Response to Conservation Design Officer Comments (24 May 2024)

41 Sheldon Avenue, N6
23002

13th June 2024

2. Gaps between buildings; No. 41 retains the largest gap

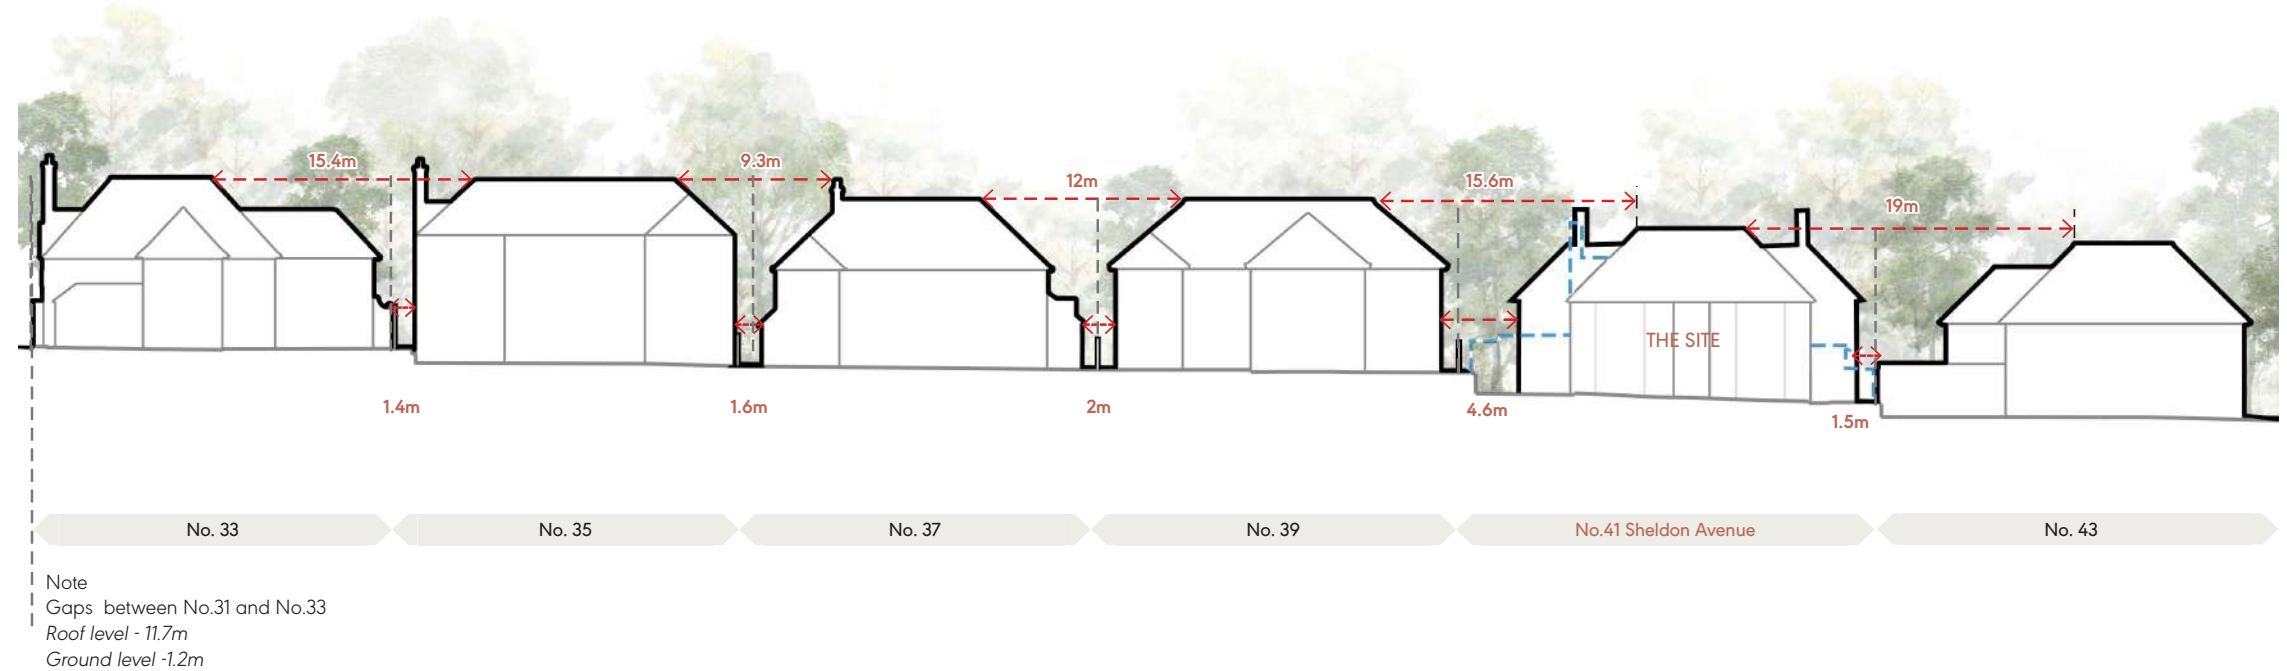
12.3.9 'Side Extensions' of the Highgate Conservation Area Appraisal and Management Plan 2013:

"...side extensions should be subordinate to the main building and relate to features of the main building..."

"When proposing a side extension the layout should aim to achieve symmetry and balance."

"In the case of an extension more than one storey high, a minimum gap of 1.5m should be maintained (from first floor level onwards) from the side boundary."

The proposal at 41 provides 1.5m to the North and 2.6m to the South boundaries, this is 1.5m and 4.6m to respective neighbouring properties.

It can be demonstrated that many properties on Sheldon Avenue do not have 1.5m between neighbours and much less from the property to the boundary.

4. Case Study;
Nos. 25-26 Sheldon Avenue

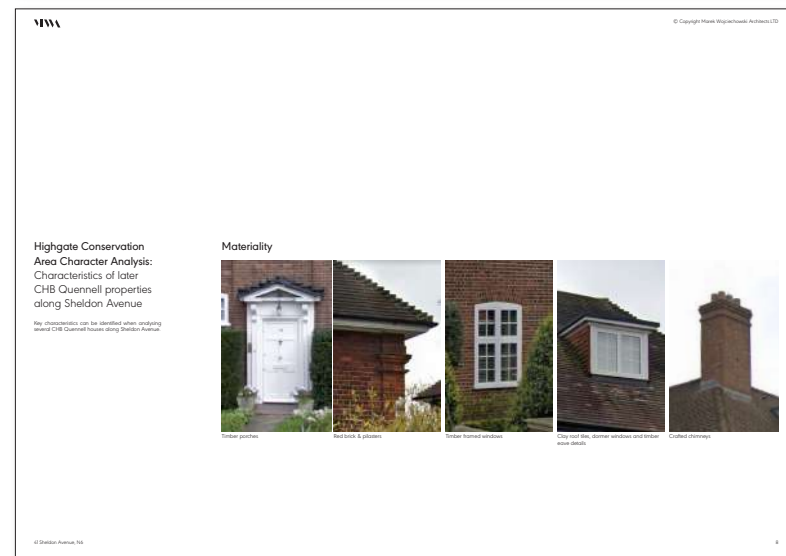
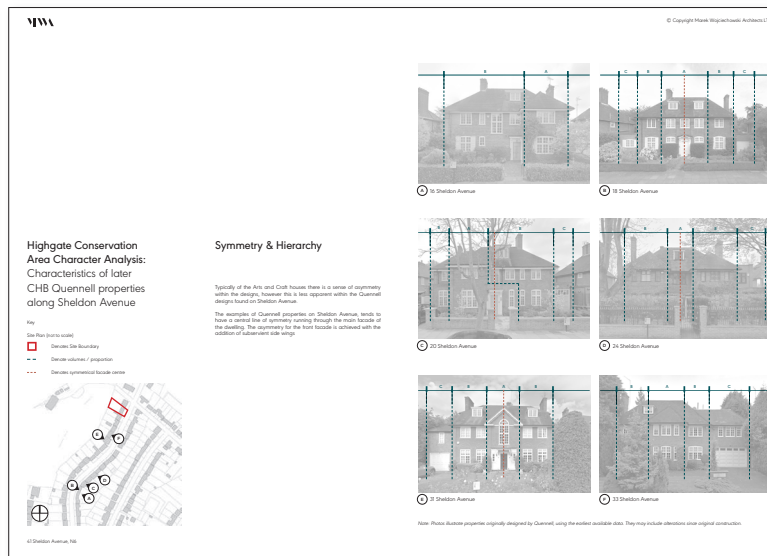
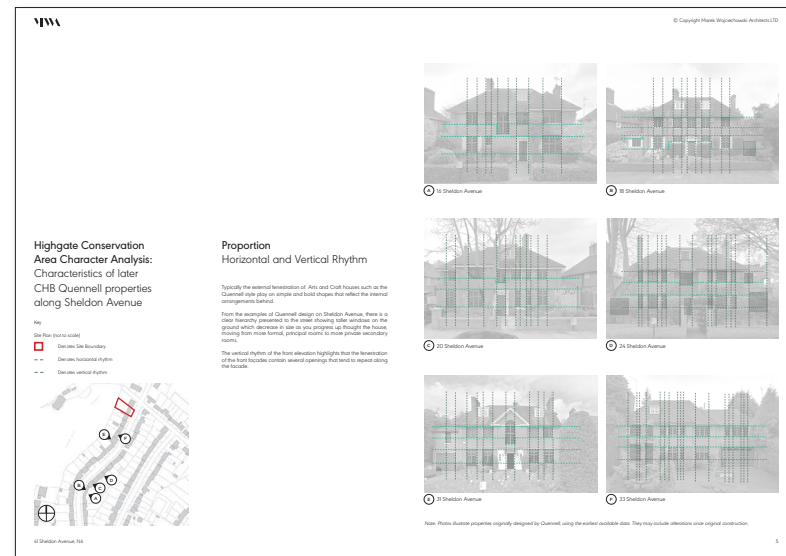
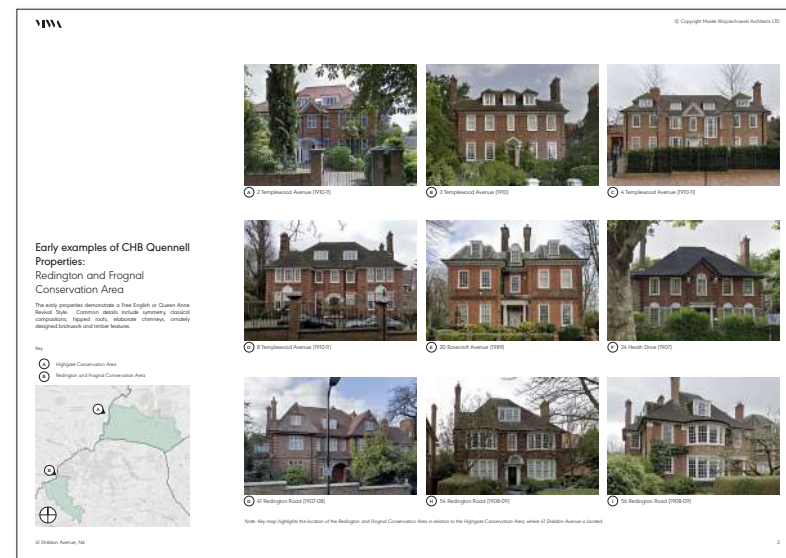
- "The proposed scheme... has been sensitively designed to maintain the existing characteristics of the plot, as well as the established spatial relationship between the house and its landscape..." MWA comment: Despite having a footprint nearly 200% the size of the existing property.
- "Front façade: [Demolition and reconstruction] amendments are minor and maintain the existing and approved character of the dwelling house. The proposed changes do not result in a material impact on the street scene..."

- "The revised plans retain sufficient gap between the neighbouring adjacent properties. The gap retained by the proposed development is similar to the prevailing pattern of development along Sheldon Avenue."
- "The proposed development would not [be] incongruent, out of keeping or [cause] harm to the character and appearance of the application site or this section of Sheldon Avenue."
- "The proposed development represents a more modern interpretation of the 'Arts and Crafts' style which is considered favourable..."
- "The asymmetrical approach is welcomed..."
- "The front boundary as detailed in the submission ...dwarf walls and piers... decorative metal fencing...preserve the setting of the conservation area."

The proposal at 41 includes many of the characteristic materials and details of the area. These include:

- Red/brown brickwork, with contrasting white windows
- Clay roof tiles
- Accommodation in the loft, lit by dormers
- Timber surround to principal entrance
- Arts and Crafts style casement windows
- Expressed chimneys
- Asymmetrical form to the street façade, suggestive of previous extension and adaption
- Low walls and metal railings to the street boundary
- Single storey garden structure to rear

9. The Revised Design: Front Elevation Details

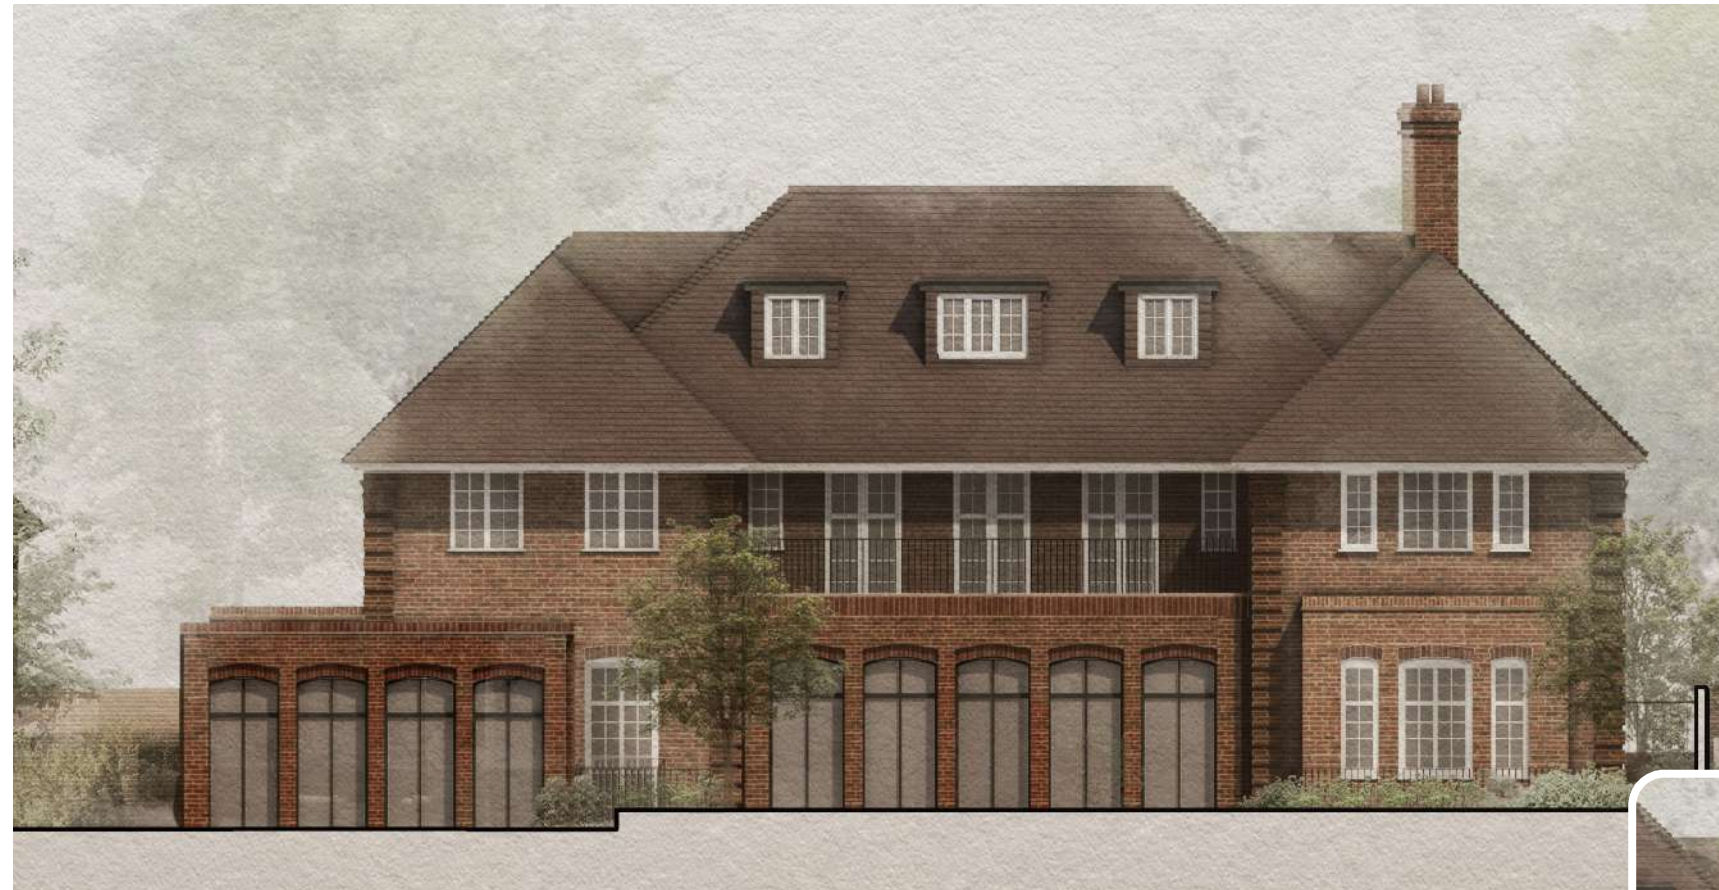
Following consultation and officer feedback we have reviewed the proposal. On consideration of the feedback against the proposed design we present here a revised scheme that has been improved by the feedback received.

- ① Front bay windows replaced with casement windows of the same proportion and Arts and Crafts style as used at the rear
- ② Walls between front and rear gardens reduced in height and separated from the side boundaries with gates

- ③ Chimneys to the North omitted to create an asymmetric roof line
- ④ Enriched brickwork detailing to the retained chimneys
- ⑤ Window added to ground floor north wing to create asymmetry at street level

- ⑥ Updated proposed landscaping including Yew hedging and multistem tree to better illustrate the visual impact of the boundary railings
- ⑦ Corbelled brick pilasters added to the corners of the main house referencing the Arts and Crafts buildings along Sheldon Avenue

Proposed casement windows
with sprung brick lintels to
mirror rear elevation

Replacement of garden walls to boundary with traditional
metal gate to enhance green gap between buildings
